RE: SE-24-00013 Horish

**SUBJECT: WDFW COMMENTS ON RU-24-00001 HORISH REASONABLE USE SV-23-00001
HORISH SHORELINE VARIANCE**

SUBJECT: WDFW COMMENTS ON SV-23-00001 HORISH SHORELINE VARIANCE

TO: All Staff
FROM: Public Works Plan Review Team
DATE: April 25, 2024
SUBJECT: SE-24-00013 Horish

Figure 1: This image comes from Page 9 of the Critical Areas Report submitted with the Horish Reasonable Use application. It clearly shows Wetland D in direct connectivity with the OHWM of a Type S water near the bottom right of this image.

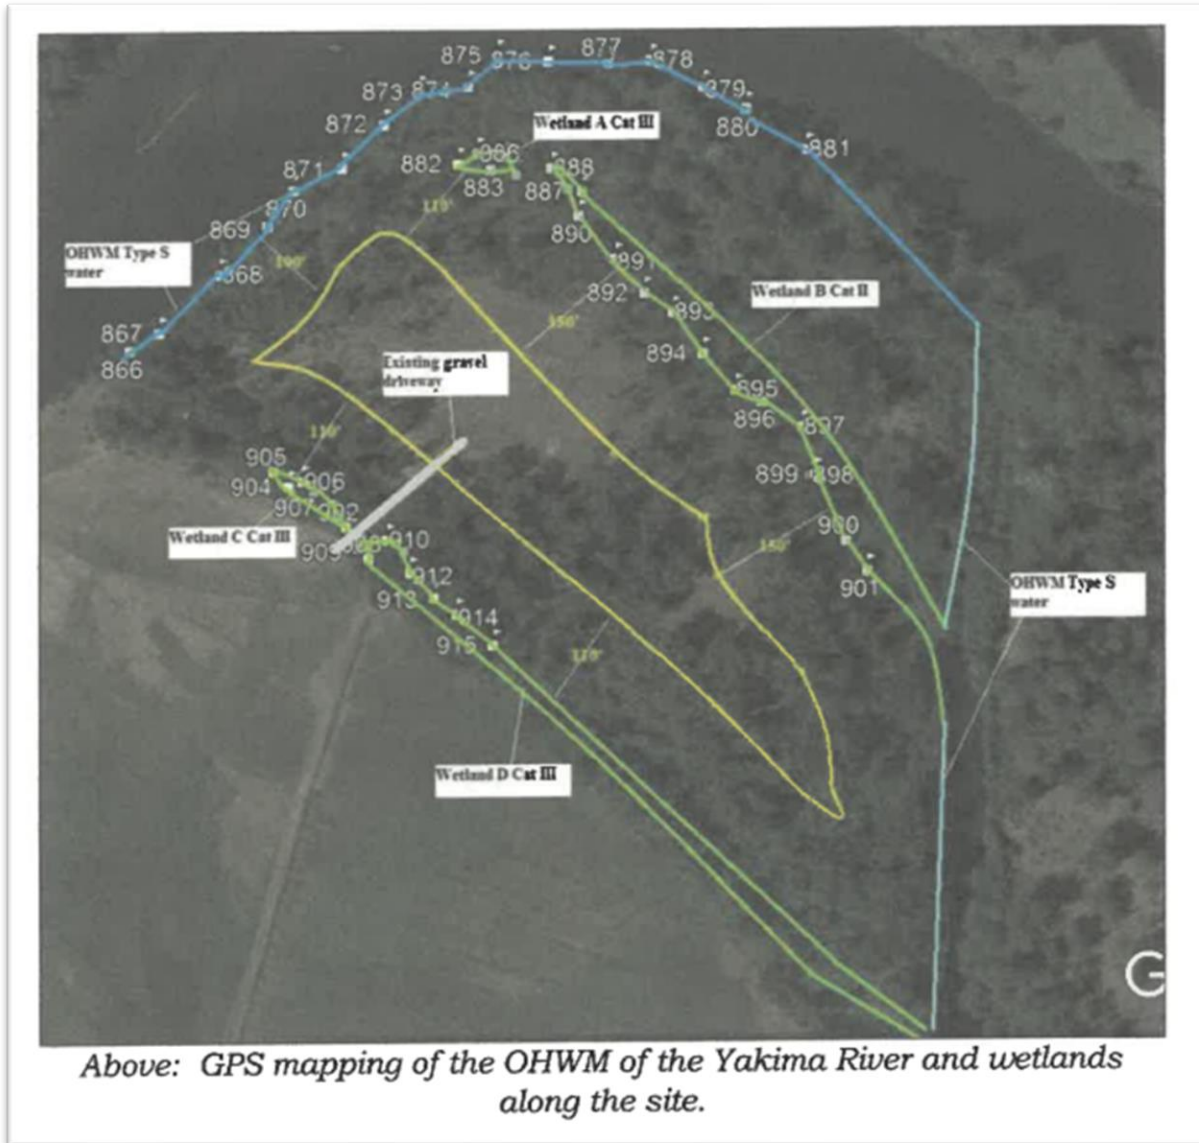
The Kittitas County Code 17B.01.020 defines the scope and jurisdiction of Shorelines in Kittitas County to include "*all shorelines of the state; upland areas (shorelands) within two hundred (200) feet of the ordinary high water mark of those waters; associated wetlands and river deltas; and floodways and contiguous floodplain areas landward two hundred (200) feet from such floodways.*" The wetlands identified in the critical areas report are directly associated with the Yakima River, a shoreline of statewide significance, and are subject to the Shoreline Master Program. The figure on page 9 of the [Critical Area Report](#) shows Wetland D terminating at the Ordinary High Water Mark of a Type S Water, a side channel of the mainstem Yakima River (Figure 1).

We do not dispute that Wetlands C and D are likely influenced by irrigation practices on the pasture south of them, but they are also hydraulically connected to the mainstem Yakima River as they are relic channel scars within the channel migration zone. These wetlands provide important fish and wildlife habitat as they are directly connected to the Yakima River, just east of the areas shown in the Critical Areas report (Figure 2).

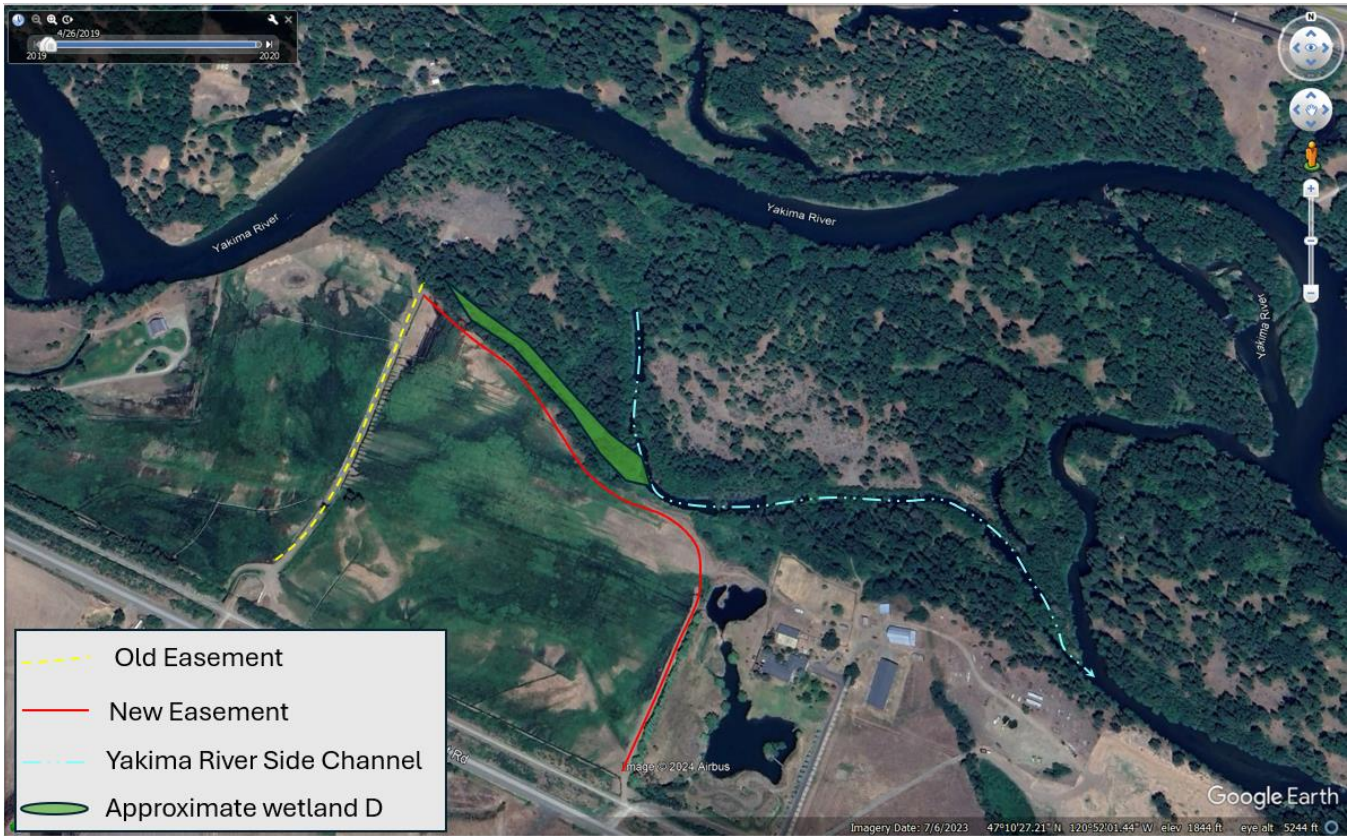
It is our understanding that Ms. Horish recently willingly relocated the existing easement across parcel 546534 to access parcel 516534. The new easement location results in the need for a new driveway that follows the terrace edge of the Yakima River floodplain and its associated side channels and wetlands; thereby creating a need for additional mitigation and potential variances from existing code. The proposed driveway falls within the buffer requirements for the Shoreline Master Program (KCC 17B) as the wetlands are in direct connectivity with side channels of the Yakima River. **The Reasonable Use considerations under the Critical Areas Code (KCC 17A) are helpful for considering impacts, but KCC 17A is not applicable in this location for this project and we recommend reconsideration of the Shoreline Variance as originally proposed.**

Figure 1. This figure shows the meandering nature of the Yakima River channels in the vicinity of the subject property (red circle). This figure comes from an October 6, 2023 [Memo](#) from Aspect Consulting to the Teanaway Ridge, LLC for RU-23-00001.

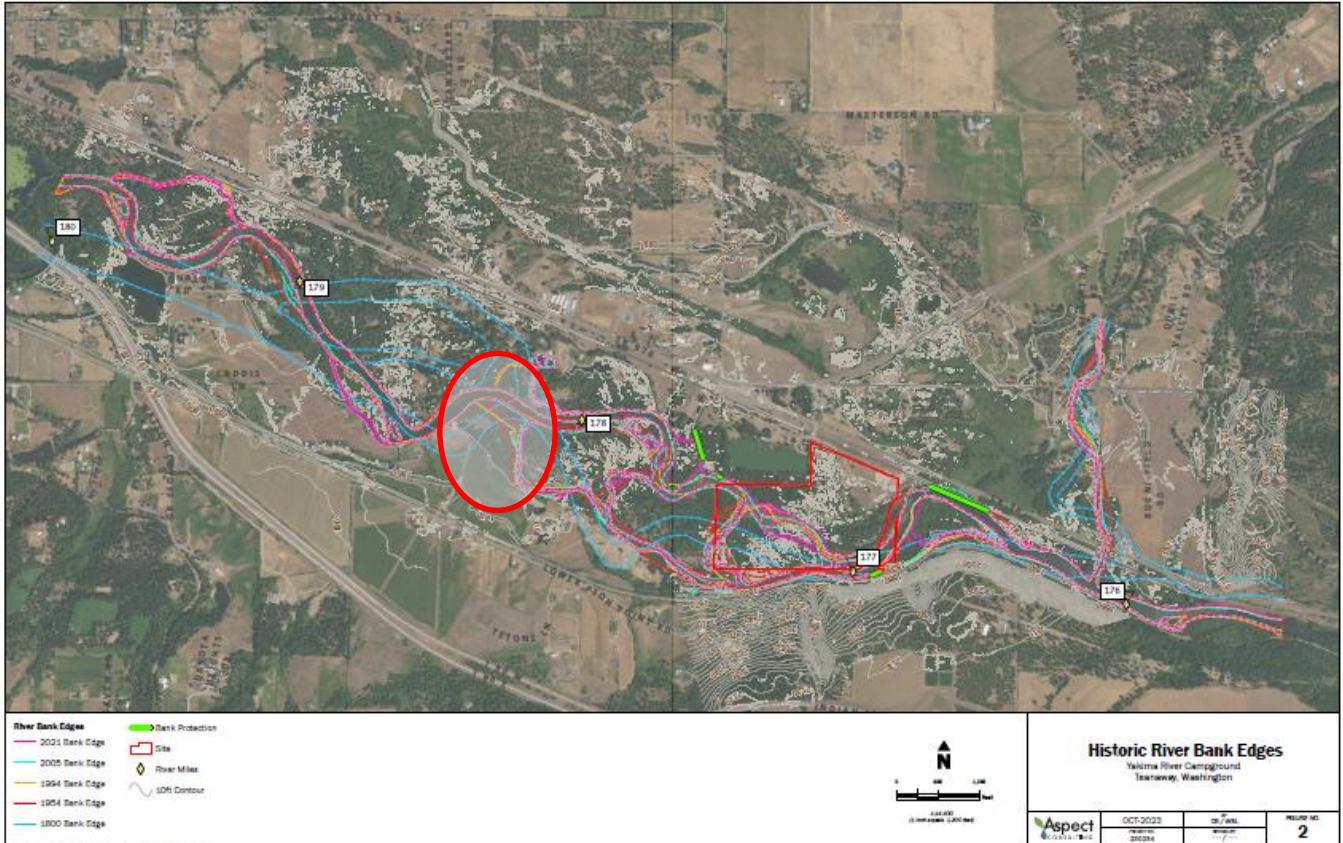
This parcel has a very real flood risk as it is within the Yakima River Channel Migration Zone (CMZ). The lidar and imagery show channel scars throughout this parcel and a recent CMZ report for a nearby project clearly confirms the active channel present within this parcel (Figure 1). From the site plan, it is difficult to tell exactly where the driveway and/or home is proposed relative to the southerly side channel of the Yakima River on the parcel. Currently, the river appears to be migrating toward the north, but as part of the active channel migration zone, we can anticipate that the river will return to its southerly alignment at some point (see Figure 2). Planning for this change now will minimize the need for emergency actions in the future. This parcel is mapped as a special flood hazard area by FEMA and flood and/or erosion risks are likely to increase with vegetation clearing and removal to accommodate road construction and home construction.
